ADDENDUM NO. 2

PROJECT NO. DGS C-0946-0012 PHASE 006

PROJECT TITLE - PA State Museum & PHMC Tower - Infrastructure Upgrades and Renovations

Design Resources Group Architects AIA
270 Davidson Ave, Suite 303
Somerset, NJ, 08873

SCALE 1/8" = 1'-0" PHMC TOWER - FLOOR EIGHTEEN 18

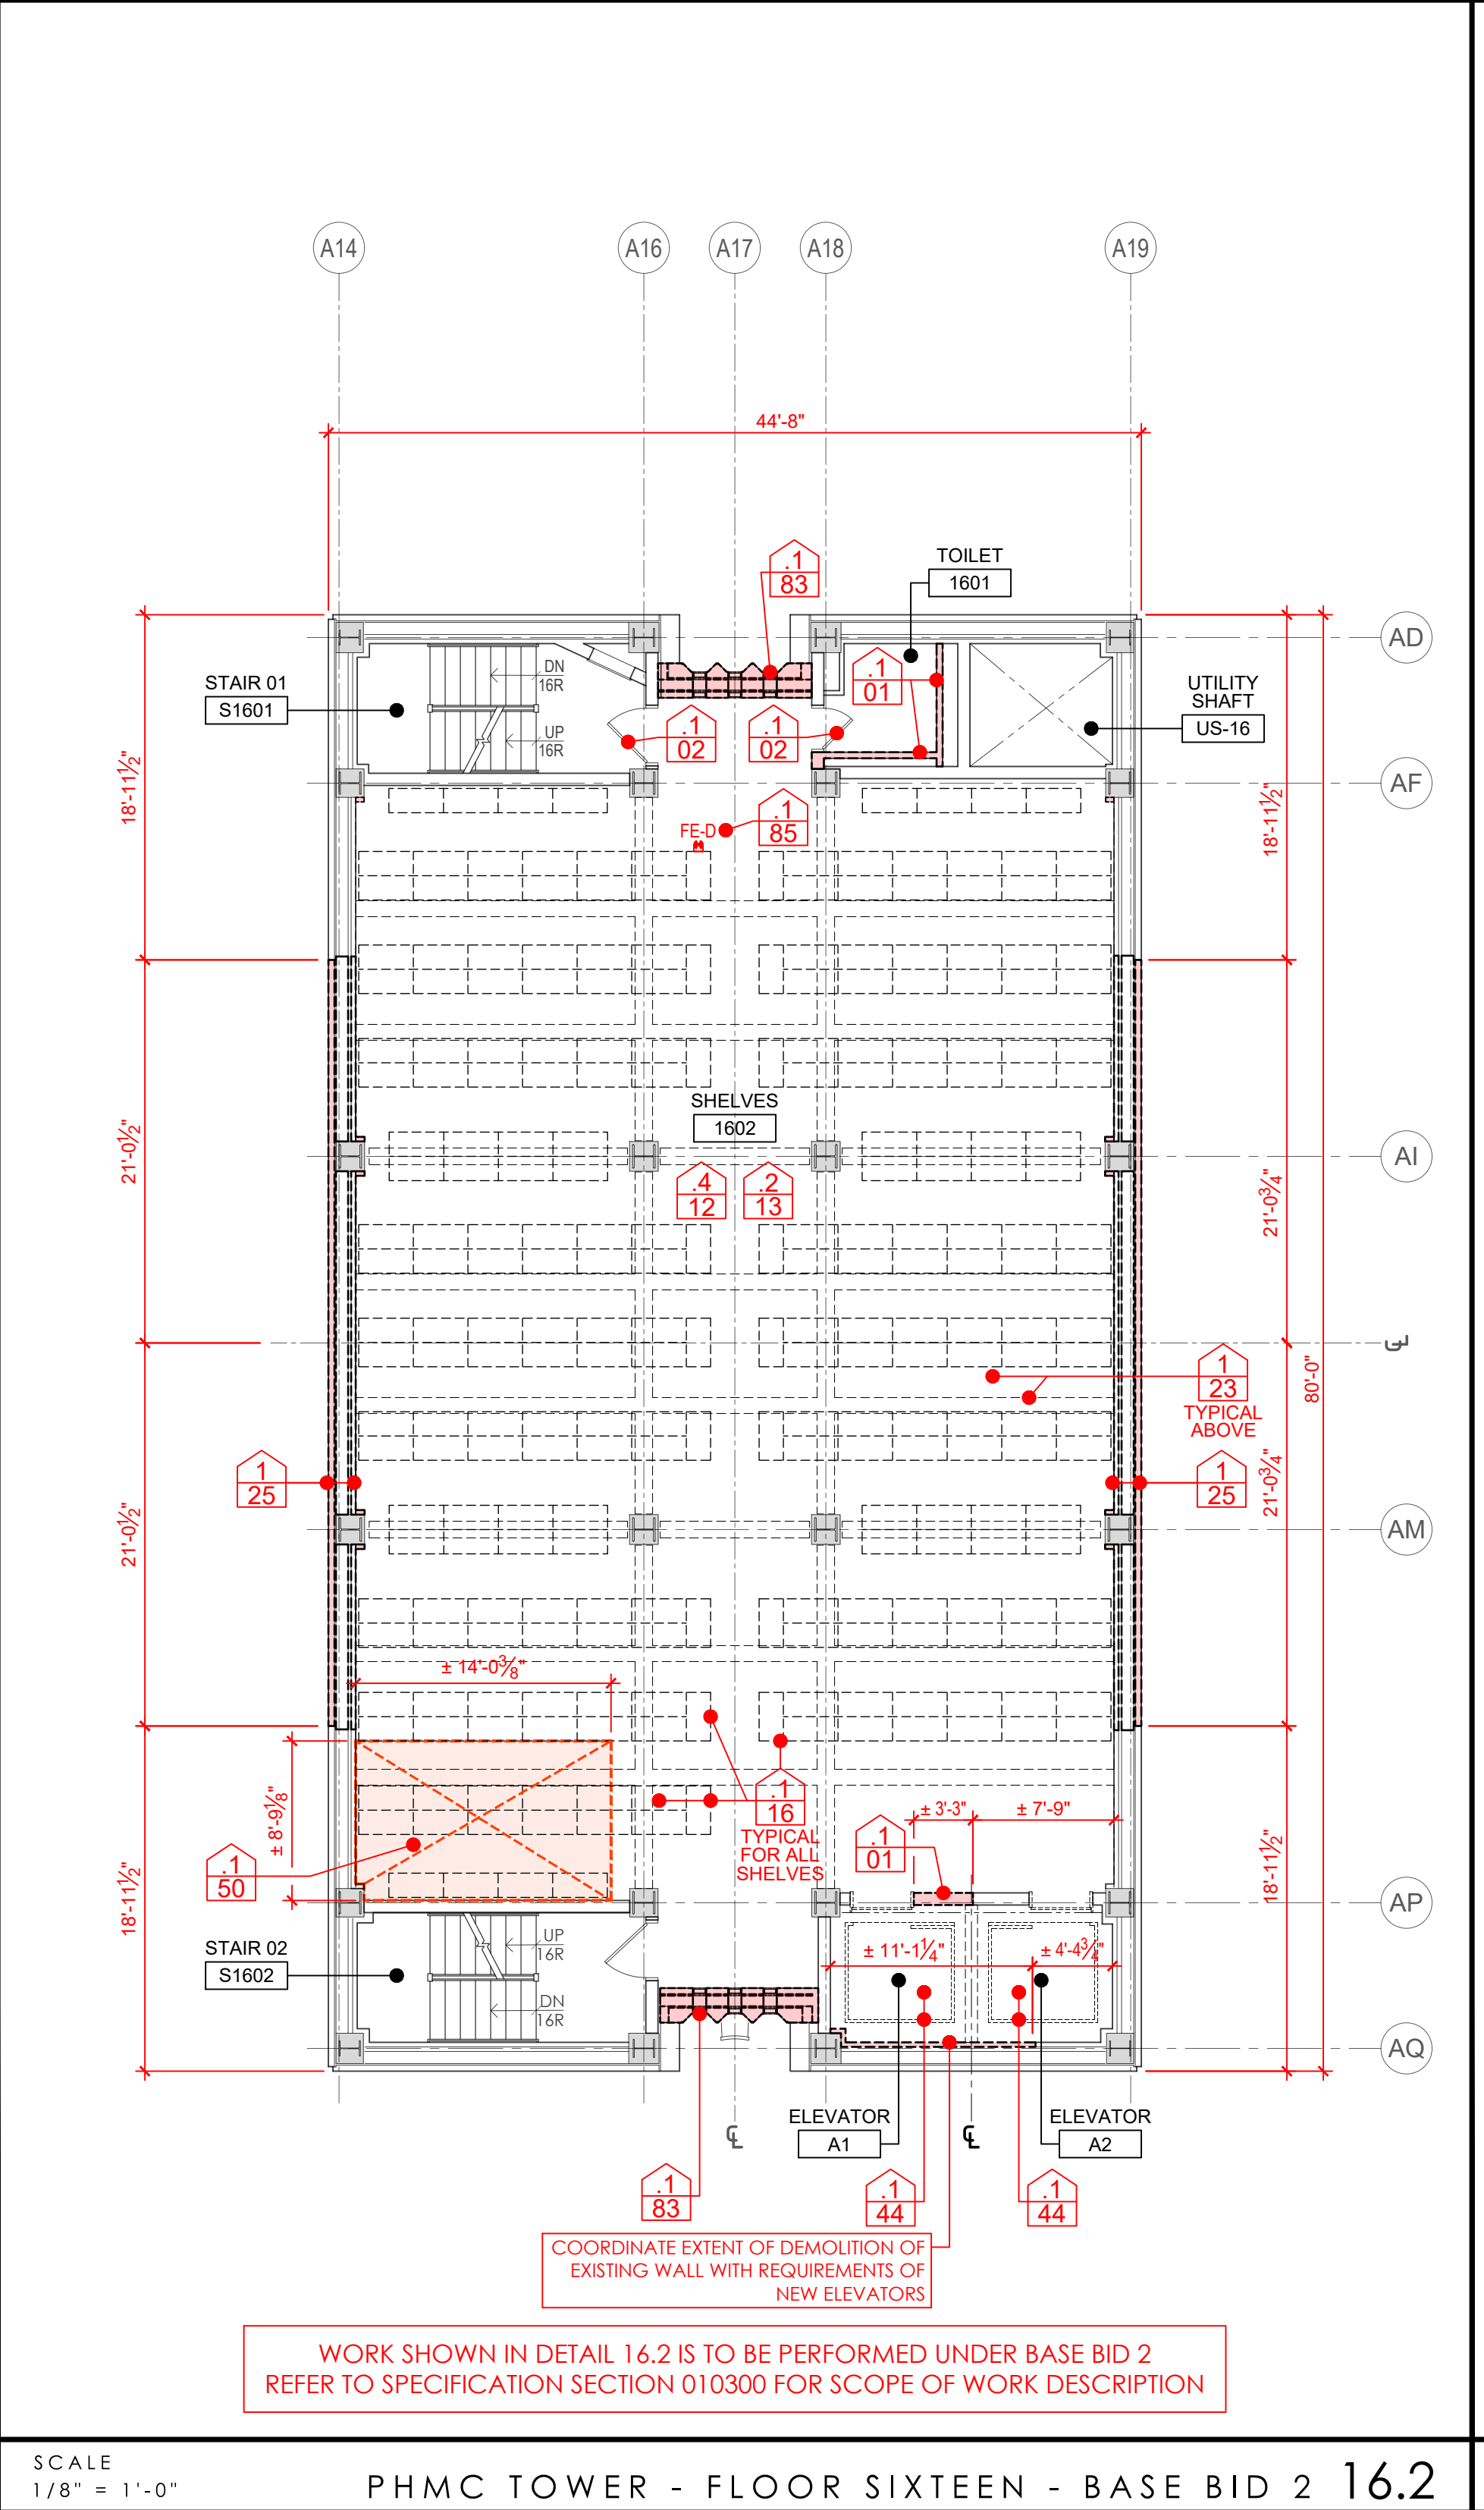
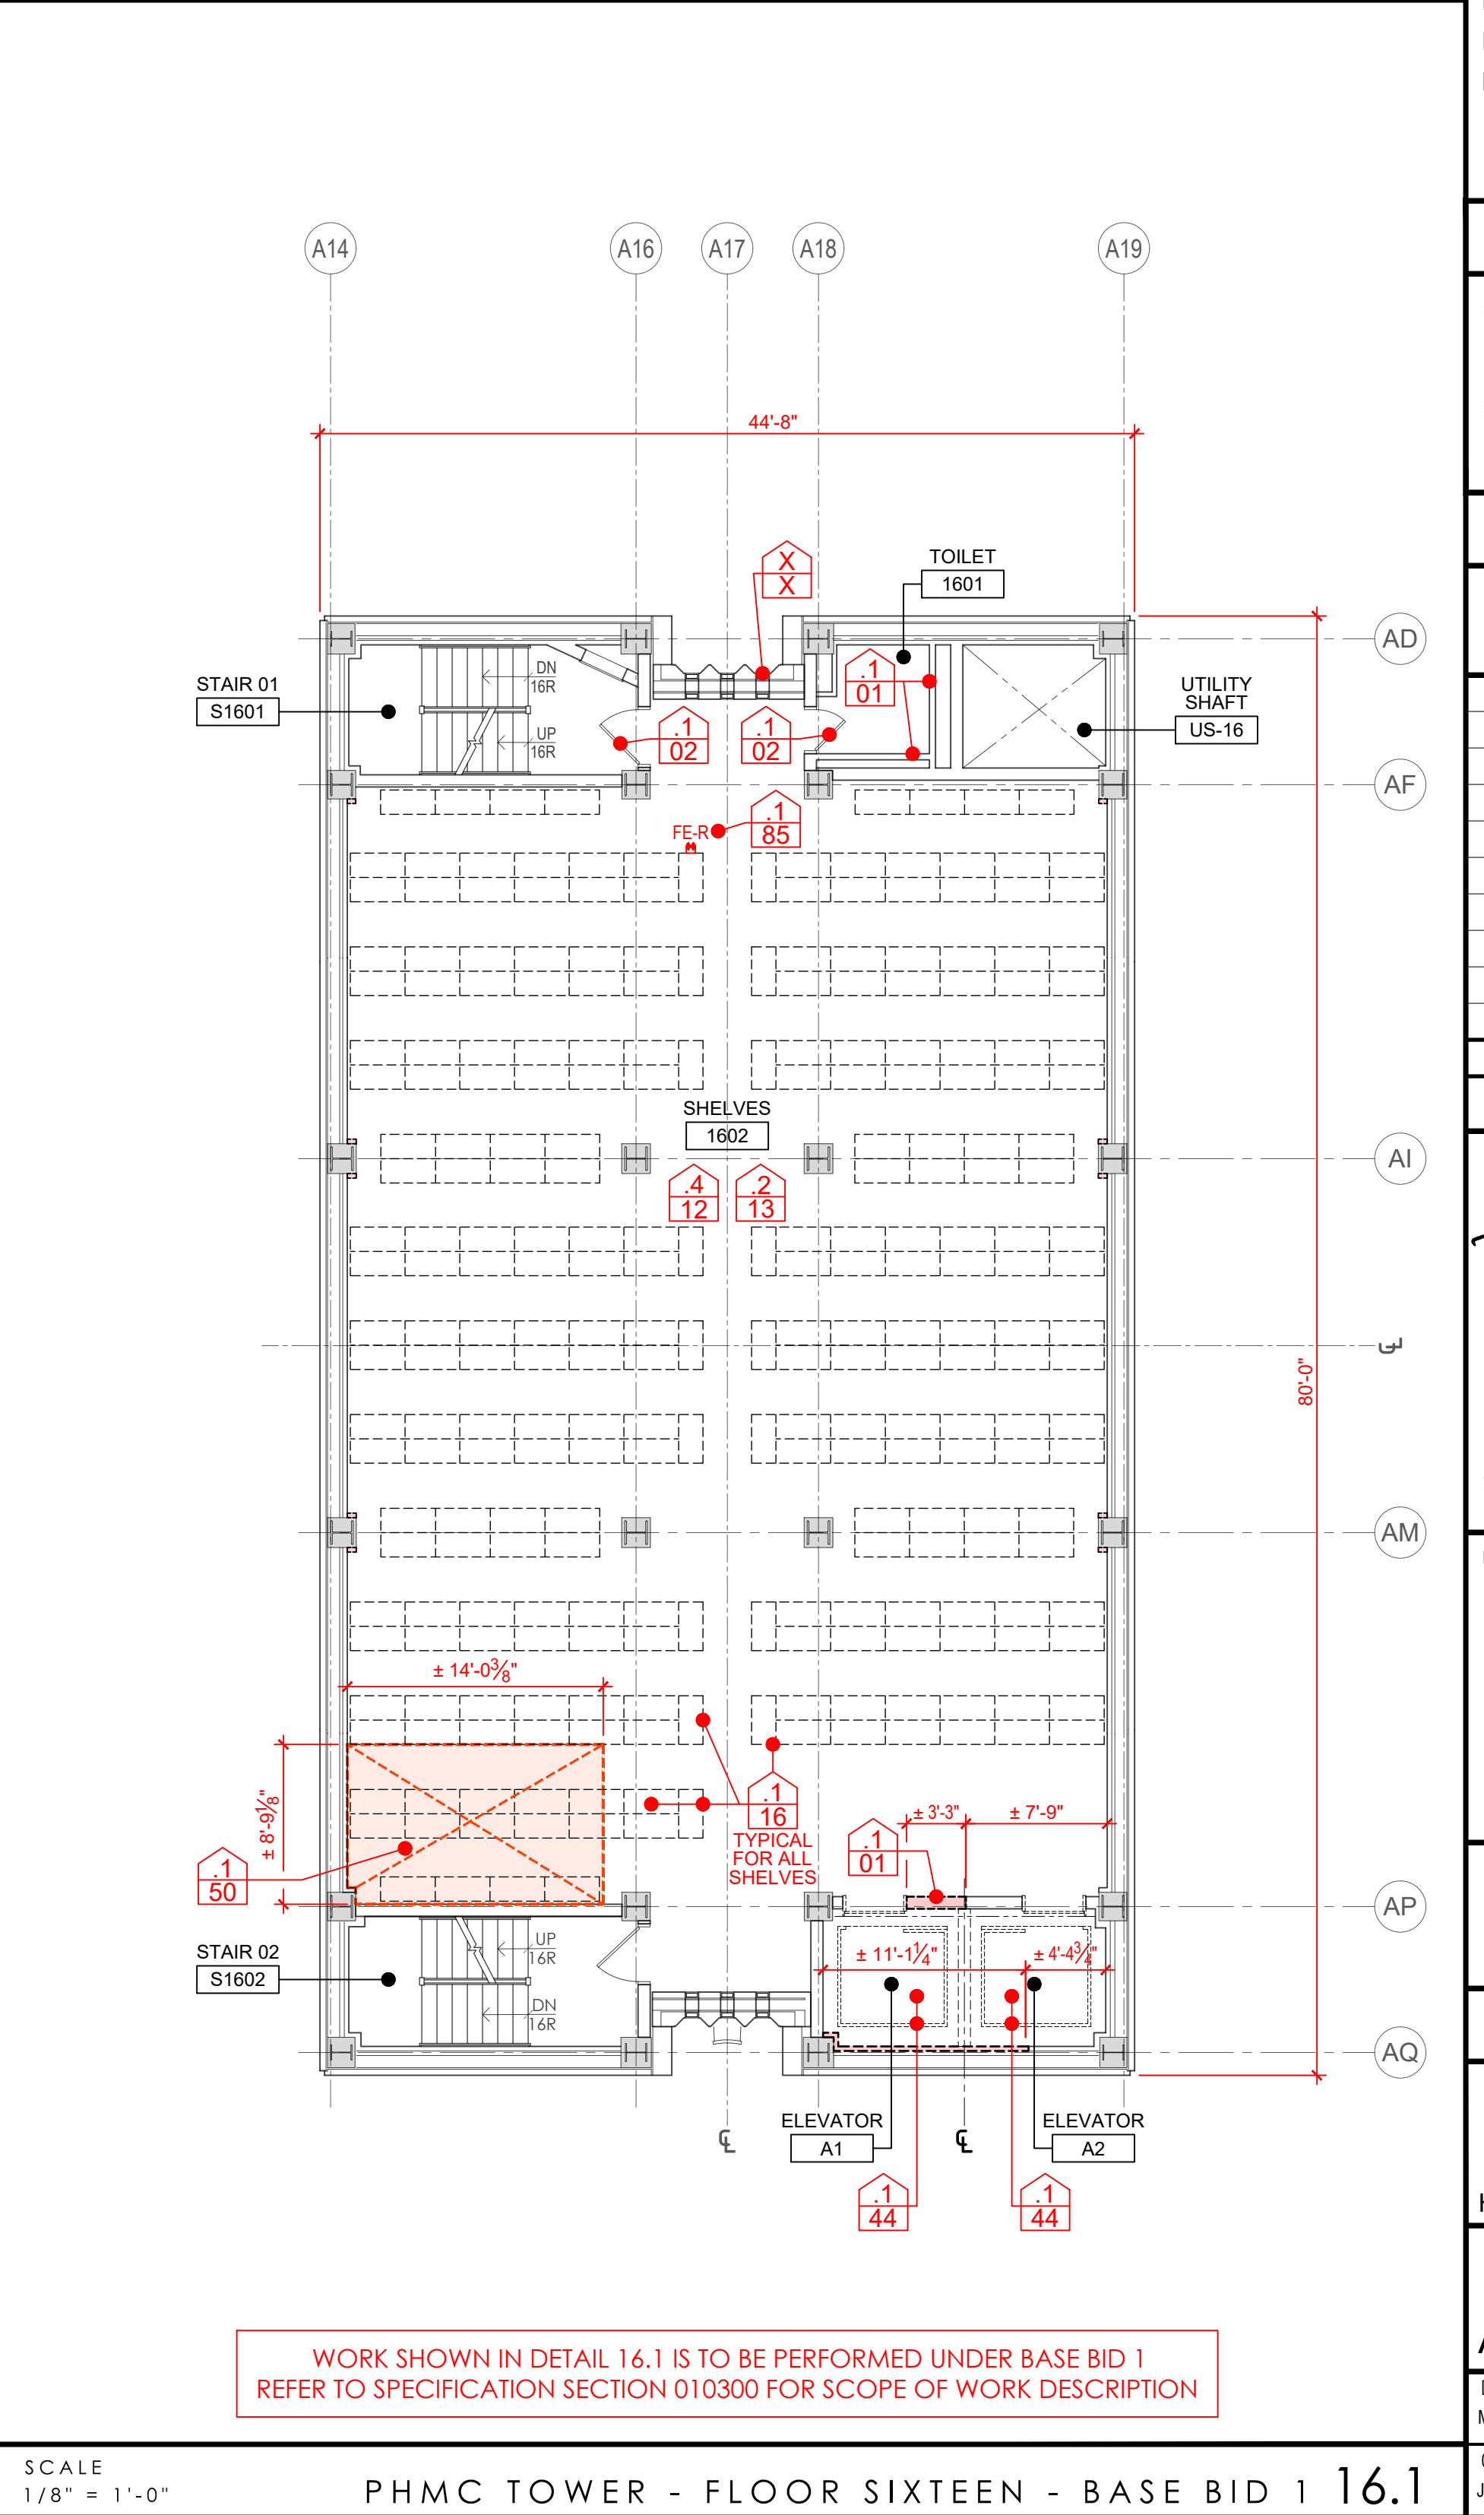
Item 13 - Drawing AD113 - At Plan 17.2, at Demo Note .1/23, deleted note reading "TYPICAL ABOVE" and added note "TYPICAL BELOW."

Item 14 - Drawing AD113 - At Plan 18, at the upper right corner, replaced Demolition Note .1/01 with .1/94.

Item 15 - Drawing AD113 - At Plan 18, at the upper right corner, added Demolition Note .1/91 covering removal of slab inside of shaft at 18th floor level.

Item 16 - Drawing AD113 - At Plan 19, added notes to show the extend of demolition of the west portion of the low roof.

Item 17 - Drawing AD113 - At Plan 20, added Demolition Keynotes.
